Re: Carlisle and Menaul - Sketch Plat Submittal

12. [PR-2024-009947](#)

[PS-2024-00123](#) – SKETCH PLAT

DRB Project Number: 2024-009947
3535 Menaul-American Square

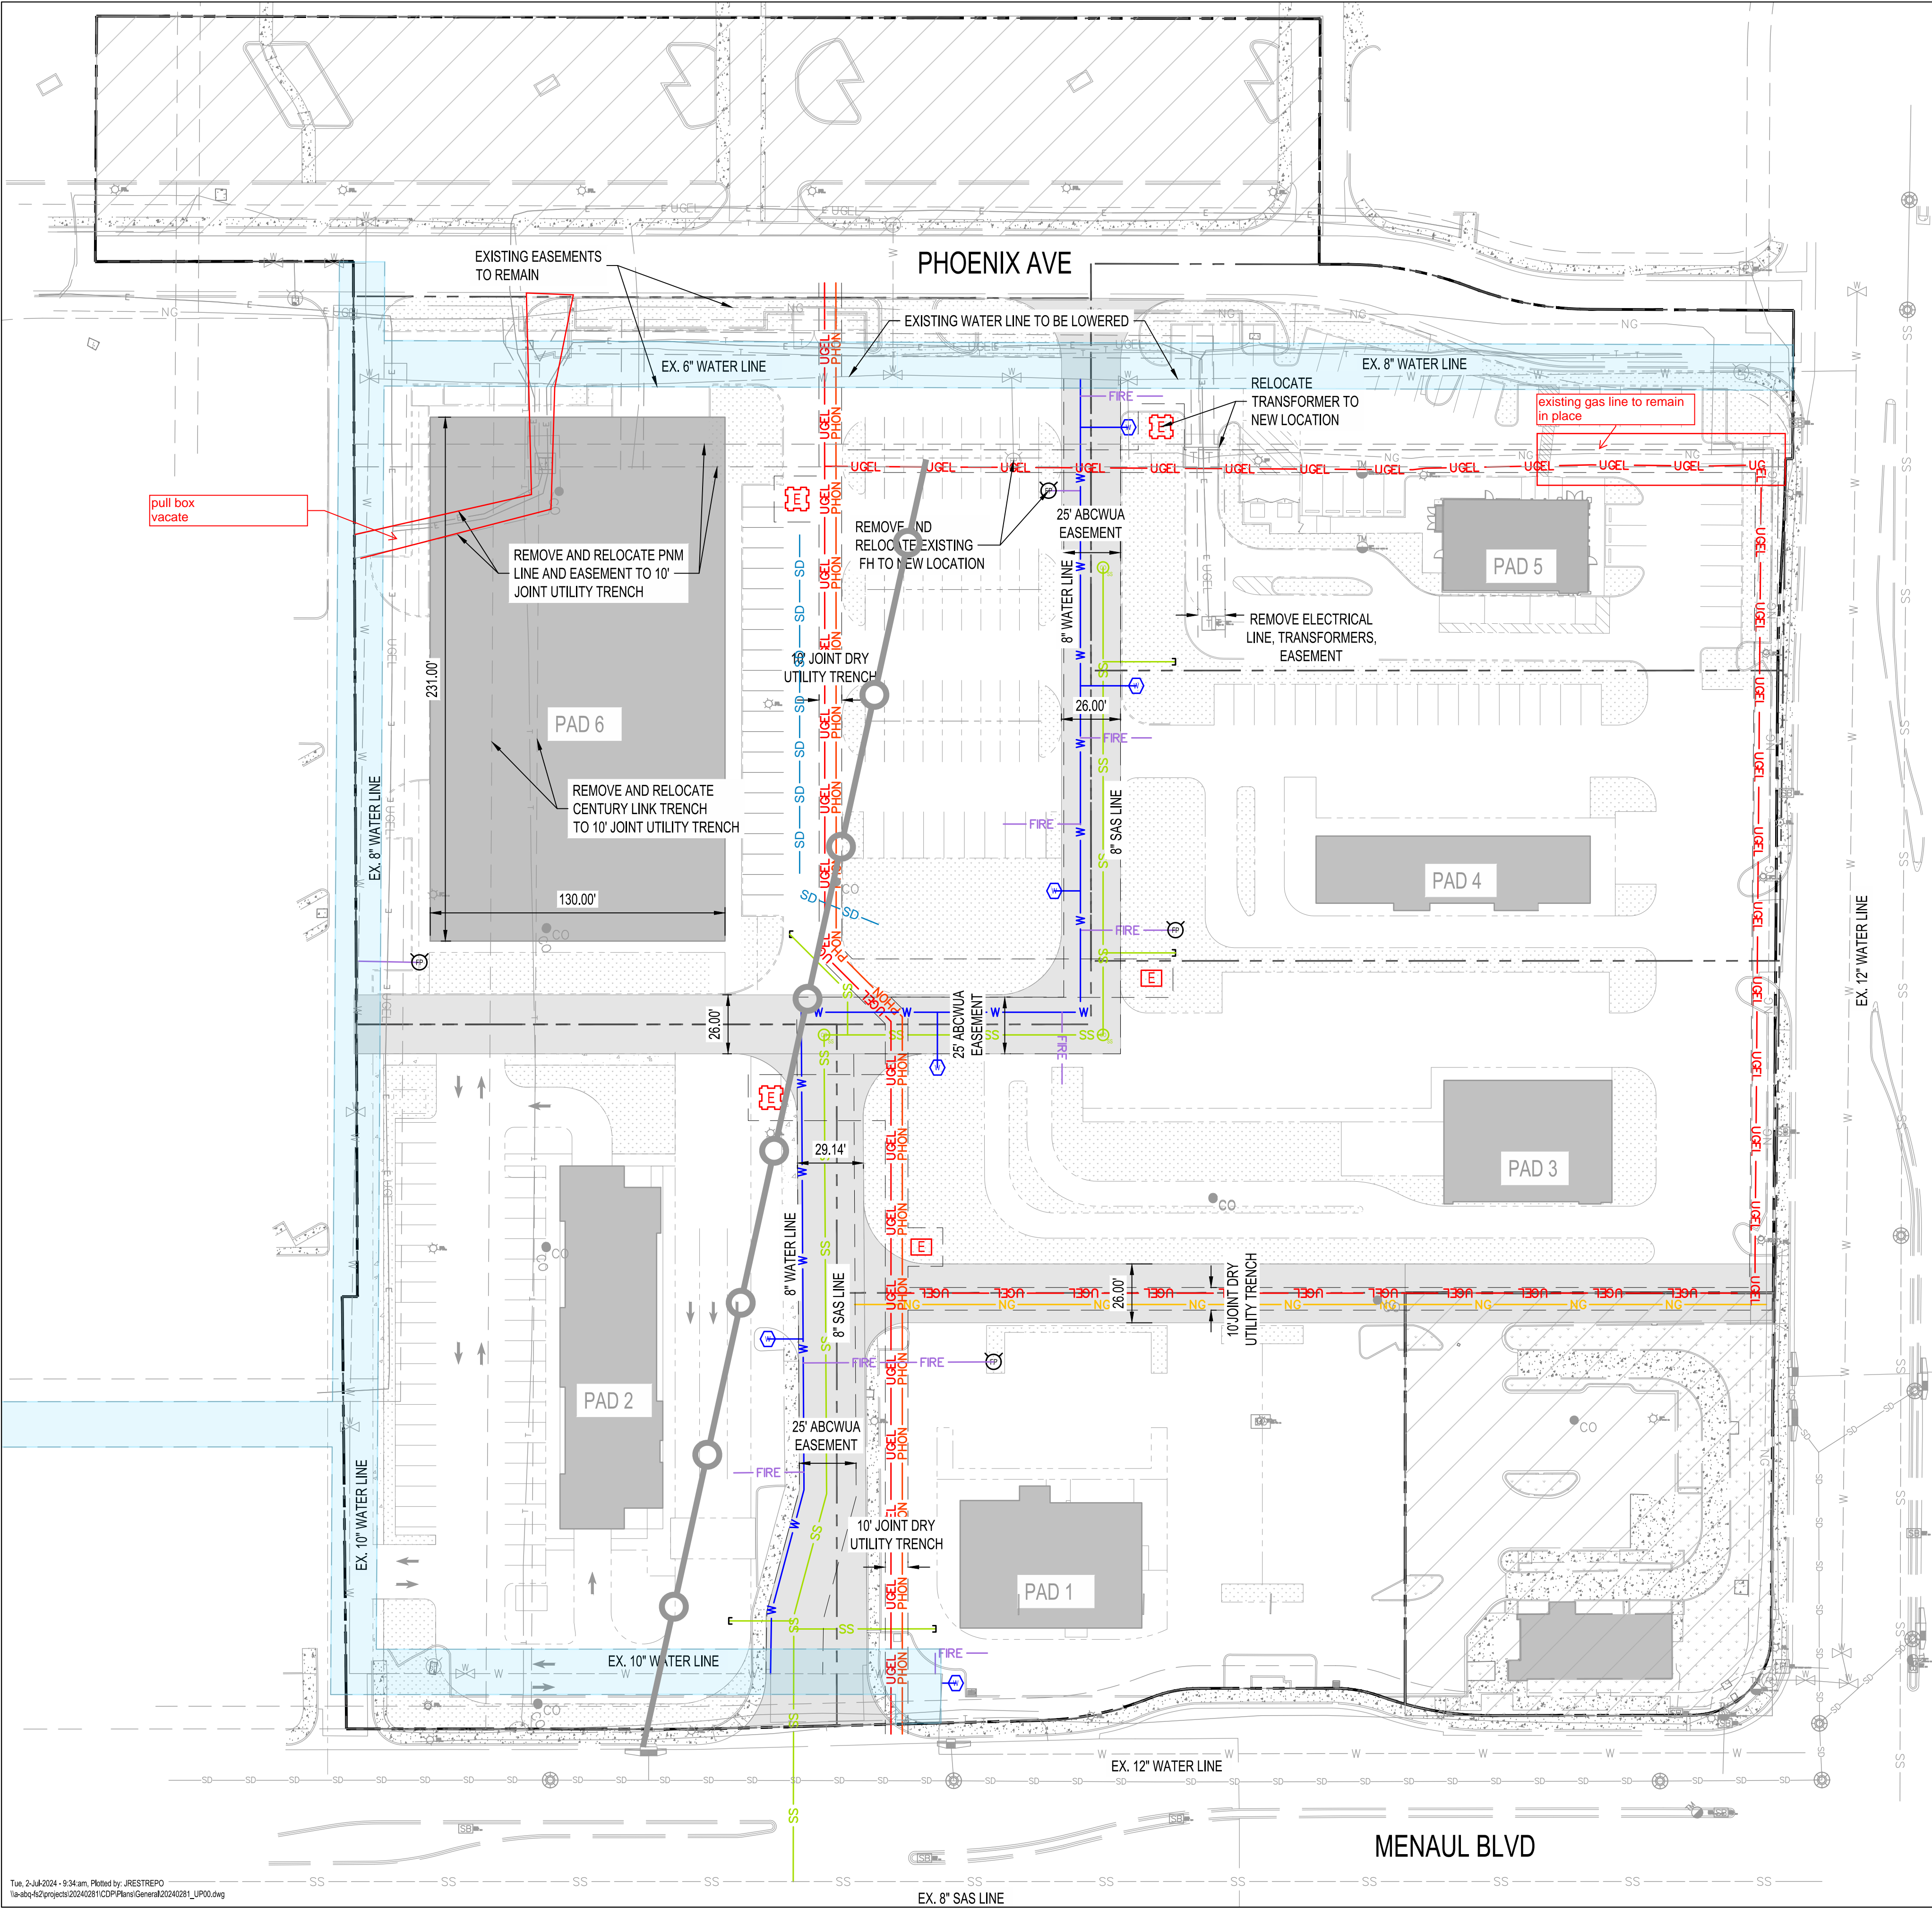
1. Menaul is a Principal Arterial and Carlisle is a Minor Arterial both in a center and both require 10' sidewalk with a 6' to 8' landscape buffer. Please provide a diagram dimensioning existing sidewalks and buffer to determine if these need to be widened.
2. All internal roads should be placed within access easements.
3. For future development an approved TCL will be required prior to site plan. Please fill out and submit a Traffic Scoping Form to Curtis Cherne (ccherne@cabq.gov) to determine if a traffic study will be required.

- Hydrology will need to approve a Conceptual Grading & Drainage Plan prior to plat approval.
- Depending on the Conceptual G&D, Cross Lot Drainage Easement note specifying the beneficiary and maintenance agreement may be needed.
- Comment – Prior to submitting for Building Permit, a licensed New Mexico civil engineer will need to submit a Grading & Drainage Plan to Hydrology for review & approval if one of these conditions is met. (500 cy of grading, 1,000 sf of proposed building, or 10,000 sf of proposed paving).

- Clarify if access and property lines for the Starbucks development will be affected.
- ***Demonstrate compliance with section 7 of the DPM Table 7.2.29 regarding Sidewalk width requirements and its landscape buffer.**
Verification of DPM standards per Transportation
Menaul is a Principal Arterial and Carlisle is a Minor Arterial both in a center and both require 10' sidewalk with a 6' to 8' landscape buffer. Please provide a diagram dimensioning existing sidewalks and buffer to determine if these need to be widened. All internal roads should be placed within access easements

Future site development will require a Street Tree landscaping plan with site plan submittal that meets the requirements in IDO 14-16-5-6(D).
